Product Advisory

Issue Date: February 20, 2020

This is an advisory on original PCN-BCA-001338; Issue date: April 1, 2019.

How to read the label?

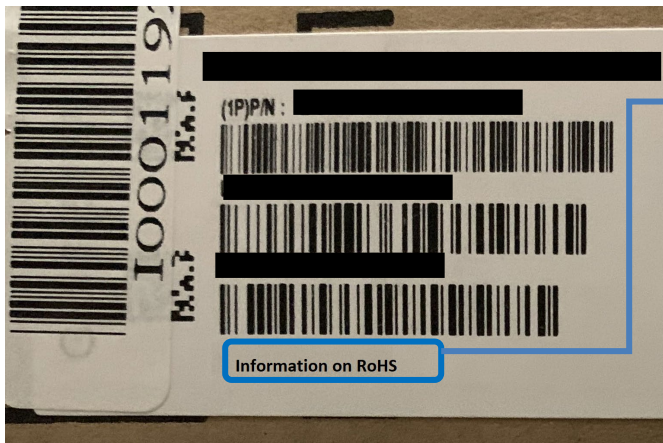
The effective date of change for the transition from Eutectic to Pb-free bumps will be a rolling change. In relation to RoHS EU directive 2011/65/EU in 2011 and its amendment Directive (EU) 2015/863 of 31 March 2015, some material shipped after March 1st 2020 will continue to have Eutectic bump interconnect metallurgy.

Below is the label information to make the necessary distinctions:

- RoHS Exempt, Non-RoHS Compliant – these are exempt under exemption 15 for shipments per current EU RoHS directive prior to March 1st 2020
- RoHS Compliant – this will be the nomenclature on Lead Free parts that are compliant to the current EU RoHS directive
